## MONTGOMERY COUNTY HISTORIC PRESERVATION COMMISSION STAFF REPORT

Address:	7411 Baltimore Ave.	Meeting Date:	2/27/2019
Resource:	Contributing Resource Takoma Park Historic District	Report Date:	2/20/2019
Applicant:	Isabelle Hasty (Paul Treseder, Architect)	Public Notice:	2/14/2019
<b>Review:</b>	HAWP	Tax Credit:	n/a
Case Number:	37/03-19E	Staff:	Dan Bruechert
Proposal:	Dormer and Skylight Installation, New A/C Compressor

- PROPOSED REAR ELEVATION.

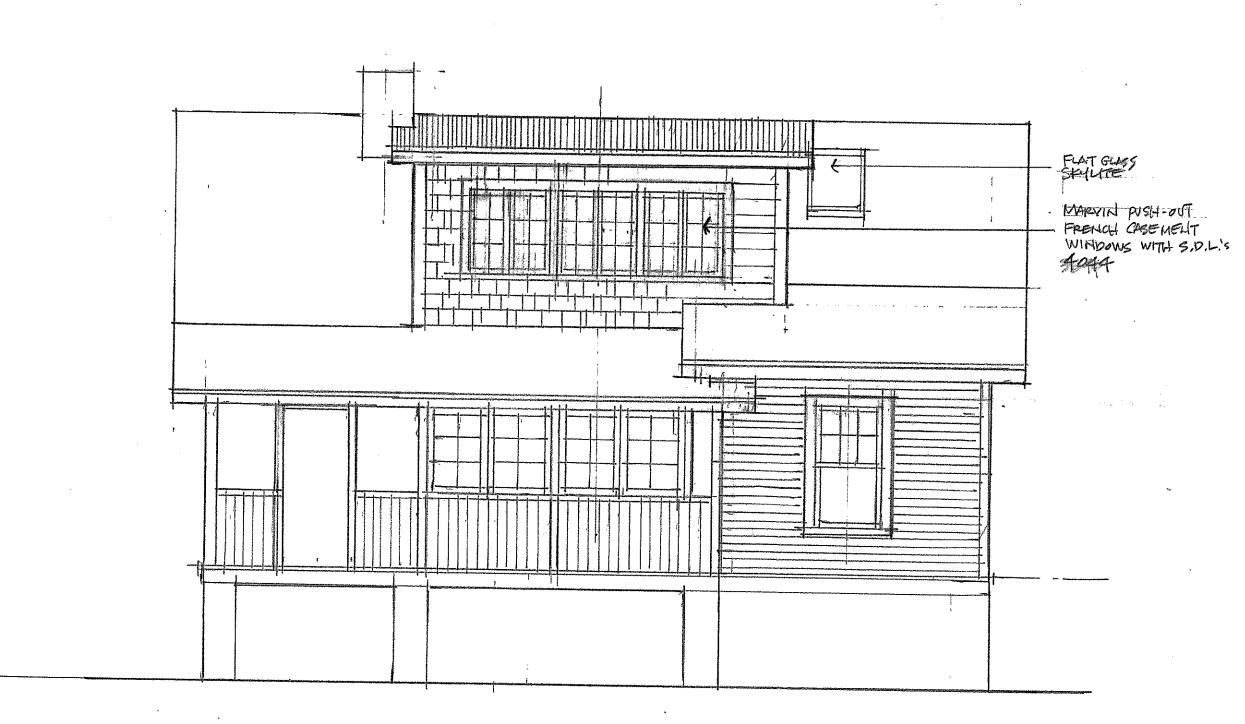
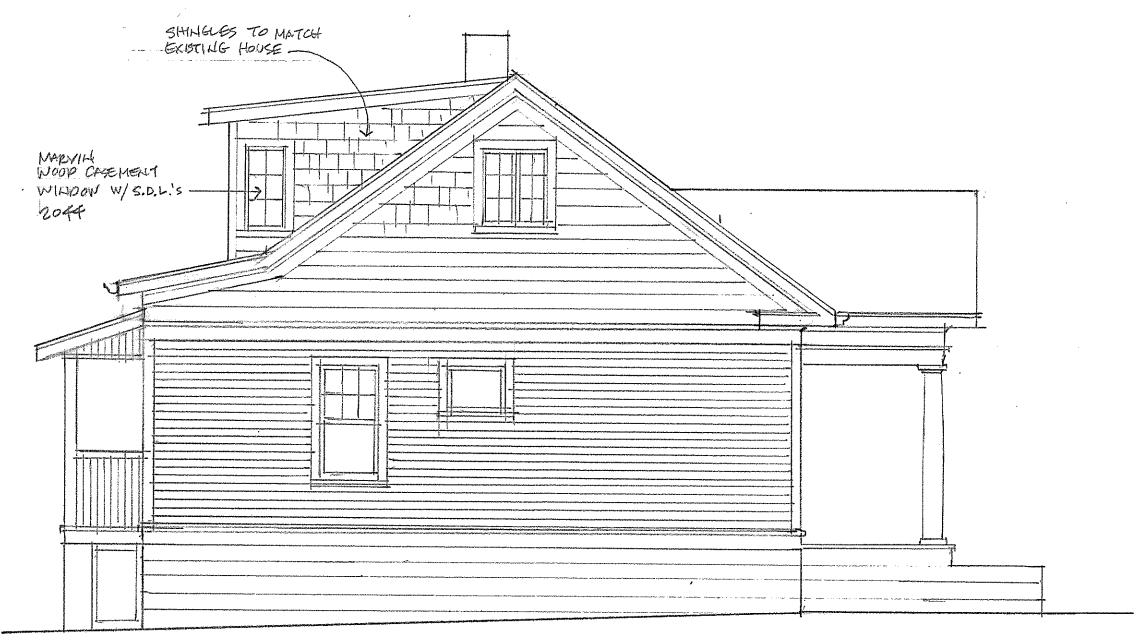
The applicant proposes to construct a new 16' (sixteen foot) wide dormer in the rear roof slope and to install a skylight on the existing rear roof slope. Staff finds that these new features are architecturally compatible with the historic resource; additionally, they will only be minimally visible from the public right-of-way. Staff supports approval.

The proposed skylight will be installed on the rear of the existing roof, inset by approximately 7' (seven feet). This feature will not be visible from the public right-of-way, and per the *Design Guidelines*, the skylight should be approved as a matter of course. Staff finds that this will not impact the visual character of the property and recommends approval under the *Design Guidelines* and Chapter 24A-8(b)(1) and (2).

proposes to construct a new shed dormer. The dormer will be 16' (sixteen feet) wide inset by 9' (nine feet) on each side. The dormer will be clad in shingles that match the siding in the gables. There will be Marvin "Ultimate" series, wood casement windows, arranged in pairs, that are based on windows in the 2<sup>nd</sup> floor gables. The narrow-sloped roof of the new dormer will be a bituminous "torch down" membrane roof.

There is a historical precedent for the "Crescent" to have a rear dormer. The advertisement for the house design (fig. 1) shows an optional  $2^{nd}$  floor configuration with two rooms could have been purchased for an additional \$300.00. The size of the optional rear dormer appears to be consistent with what is currently being proposed. While the design of the dormer is not included in the advertisement, Staff assumes that it was designed to be consistent with the architectural features found in the rest of the house massing. Staff finds the design of the proposed addition is generally consistent with the design of the house and achieves the goals of the *Design Guidelines*.

Staff finds that the proposed materials, i.e. shingle siding, wood windows, and wood trim are all appropriate with the materials on the building and surrounding historic district. In most other circumstances, Staff would not support a membrane roof, however, due to the low slope of the dormer roof, an asphalt shingle roof is not recommended. Additionally, this roof will not be at all visible from the public right of way and will likely not be visible from anywhere on the property. Staff finds the materials to be appropriate for the building and district.

Staff finds that because there is a historical precedent for a rear dormer, that the dormer is an appropriate design, and that the proposed dormer addition and skylight will have a minimal impact on the historic character of the house and surrounding district, Staff supports approval under 24A-8(b)(2) and the *Design Guidelines*.

Staff recommends that the Commission **approve** the HAWP application; and with the general condition applicable to all Historic Area Work Permits that the applicant will present 3 permit sets of drawings to HPC staff for review and stamping prior to submission for permits (if applicable). After issuance of the Montgomery County Department of Permitting Services (DPS) permit, the applicant will arrange for a field inspection by calling the DPS Field Services Office at 240-777-6370 prior to commencement of work and not more than two weeks following completion of work.
